MEMORANDUM

SUBJECT: SF-18-008 – Lorson Ranch East Filing No. 1
Response to Comments - First Submittal

Final Plat

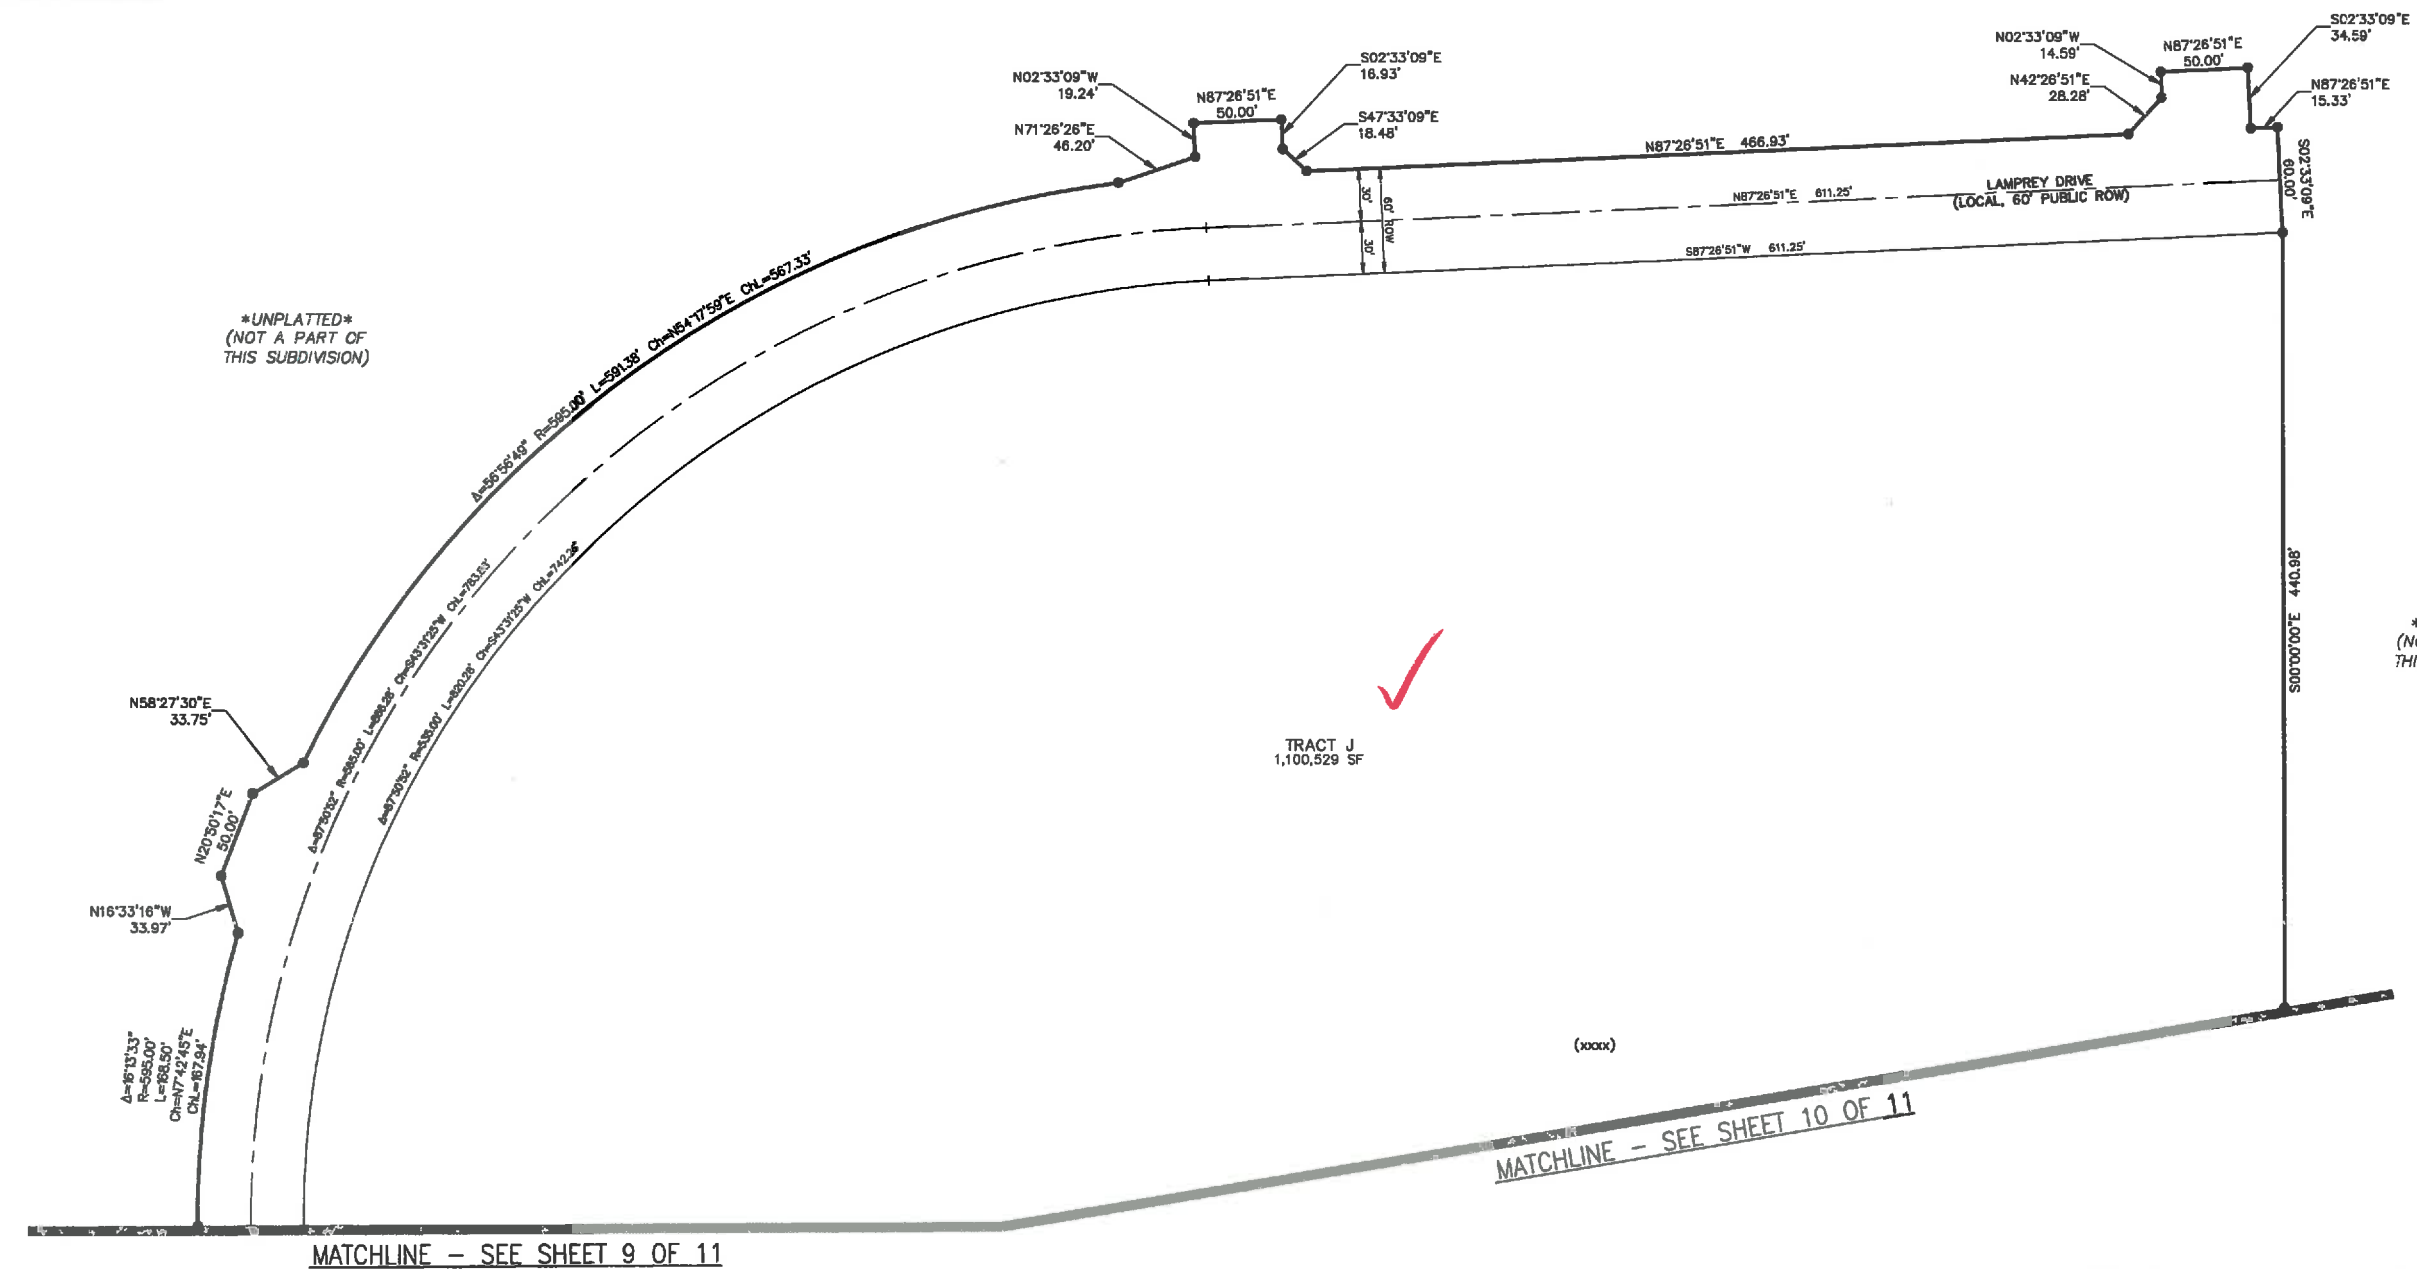
Label purpose and correct for round about and add easements for additional row

The school site is conditioned to pay traffic fees. This should be noted in the note o sheet 2.
